Stage 6: Final Grid Code Modification Report		At what stage is this document in the process?												
<h1 style="color: #00a651;">GC0114:</h1> <h2 style="color: #00a651;">Mod Title: ‘System Operation Guidelines Prequalification Processes’</h2>

This document is the Final Grid Code Modification Report document that contains the discussion of the Workgroup which formed in June 2018 to develop and assess the proposal, the responses to the Workgroup Consultation which closed on 27 September 2018, the voting of the Workgroup held 05 December 2018. The Panel reviewed the Workgroup Report at their Grid Code Review Panel meeting on 19 December 2018 and agreed that the Workgroup had met its Terms of Reference and that the Workgroup could be discharged. This document also contains the responses received from the Code Administrator Consultation which closed on 28 January 2019.

GC0114 aims to clarify that the EU System Operation Guideline (SOGL) requires NGENSO to develop prequalification processes for Frequency Containment (FCR), Restoration (FRR) and Replacement Reserves (RR). In line with stakeholder feedback NGENSO proposes to develop these new processes under the established governanc

Figure 5 – Static FFR ramp test requirements (copy FFR Guide Figure 2.1)

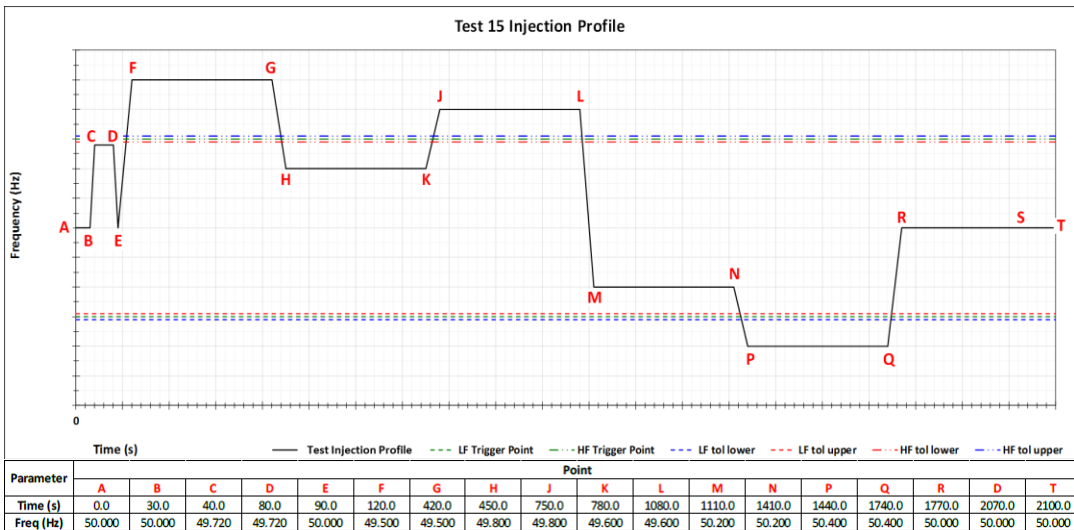
FFR Static service tests require a series of 30 second ramp tests an example of which is shown in figure 5. It would seem logical that the duration tests which are in the dynamic section would be included for the Static service but they do not seem to be.

Figure 8 – EFR duration test requirements (copy EFR Guide Figure 2.5)

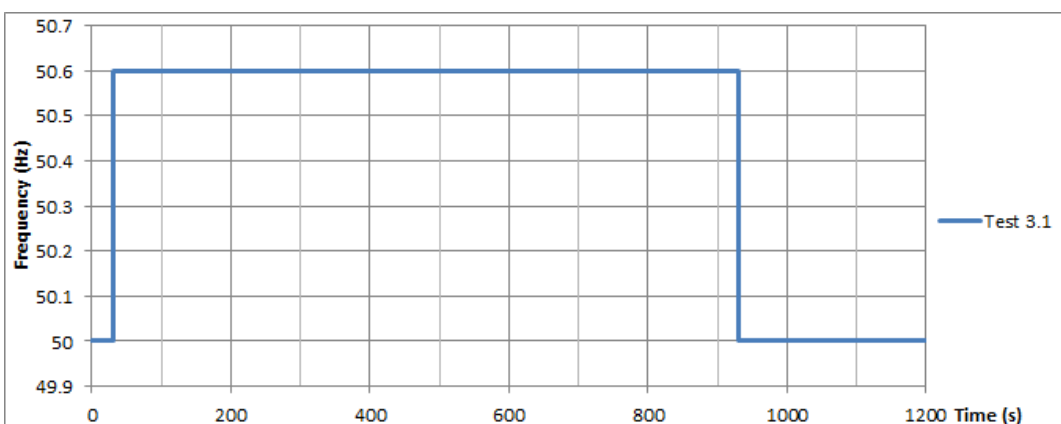
EFR duration test shown in figure 8. Flexibly has been added to the new tests to allow them to be easily applied to new trigger levels and new duration lengths. These additional tests will also be added into OC5 or into ECP and CP.

Figure 10 – Comparison of responses to a -0.5Hz step and ramp test

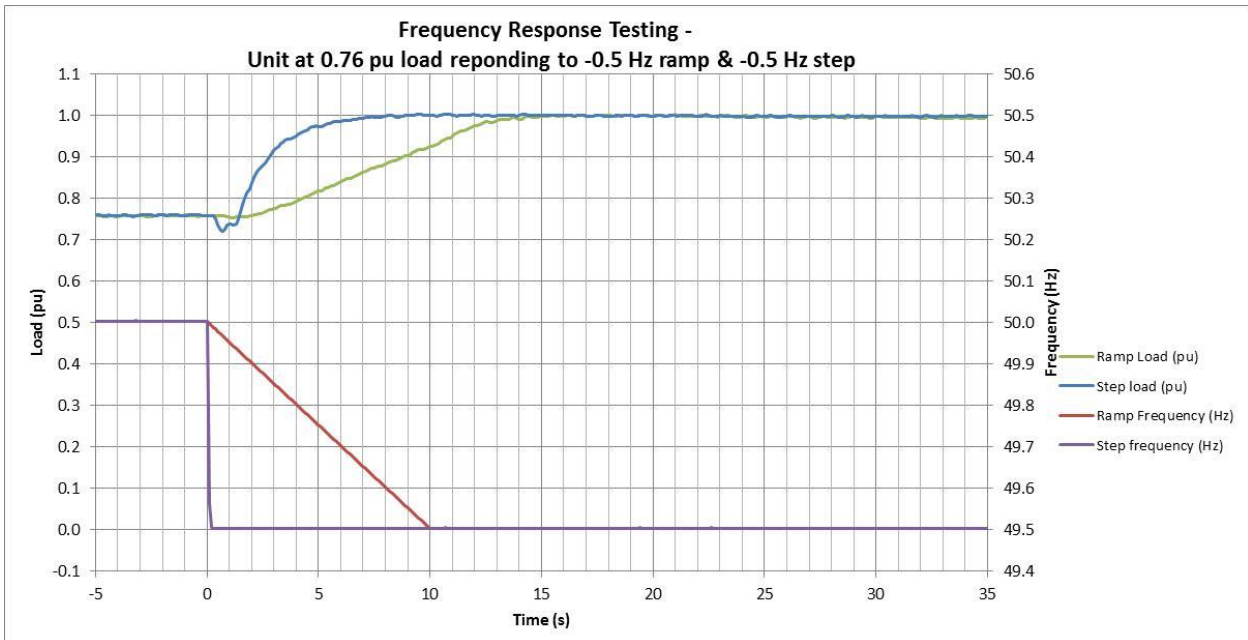
Reviewing the primary response in figure 10 based on a 10s ramp the response is 0.186 pu, whilst if the result is based on a step test the response is 0.241pu, hence a ramp test only gives 70% the response of a step response. Similarly the high response in figure 11 based on a 10s ramp the response is 0.191pu, whilst if the result is based on a step test the

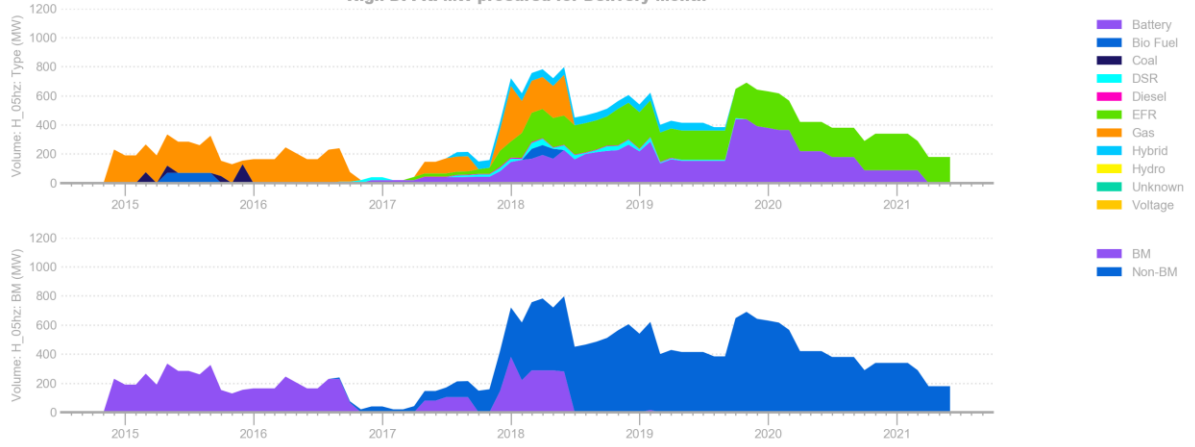
We agree wholeheartedly that it is right that FFR testing requirements should be set out in detail in a contract, that they should be for all to see, that they should apply to all parties equally, and that all providers should know what terms of service delivery they are signing up to at the point of signing a contract with National Grid. Demand Side Response providers of FFR have undertaken a detailed piece of work with National Grid's FFR Testing team to develop an updated set of FFR tests more suited to FFR Units made up from multiple sites and composed of multiple technology types. Such work would not have been possible had the FFR Testing guidance have been contained within the Grid Code and Non-BM FFR providers needed the assent or sponsorship of Grid Code parties to raise a change.

High DFFR: MW procured for Delivery Month

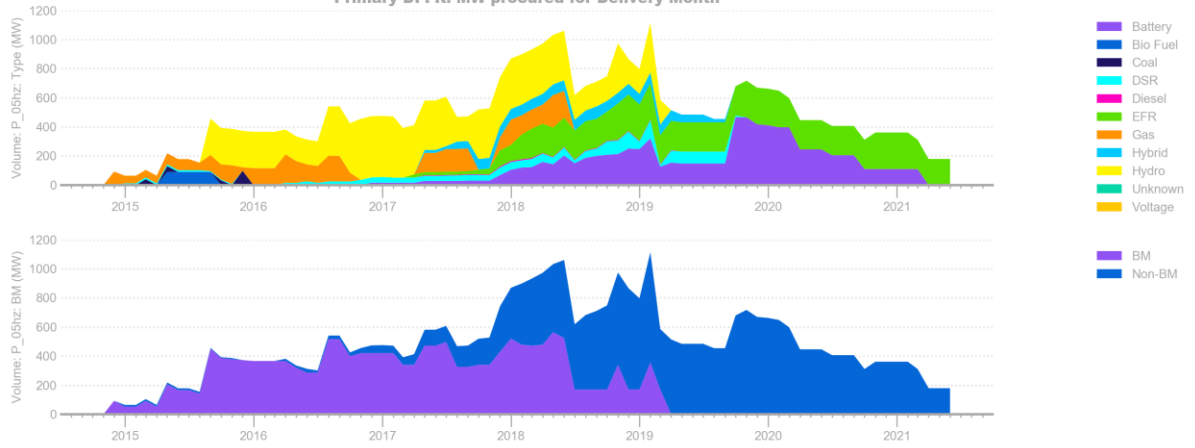
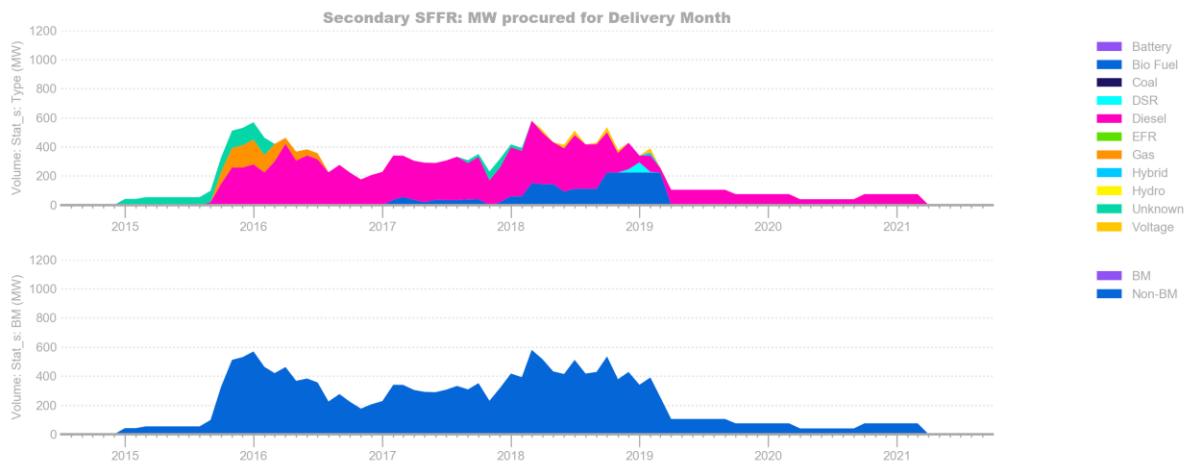
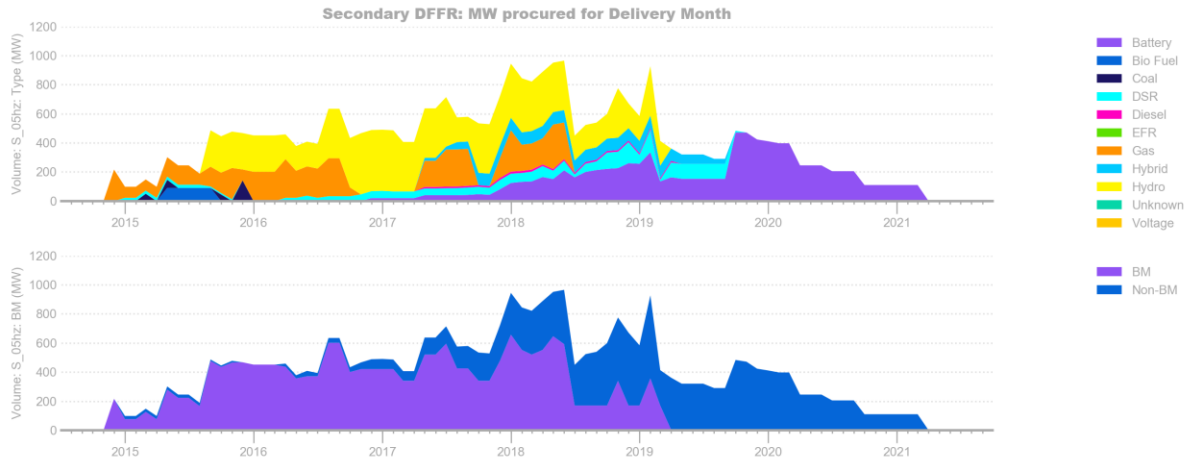
The nature and form of the Frequency Response markets is currently going through a period of rapid change:

The market is yet to find out what the landscape will look like for these services, which services will replace current services, how different markets will work alongside each other, etc. Given that testing requirements for many of these services are as yet unknown, it would be inappropriate of National Grid to fix the Frequency Response testing requirements into the Grid Code, where any necessary modifications to match evolving market conditions would take a much longer time than the markets would require, and which would impact service providers not party to the Grid Code to an unacceptable degree.
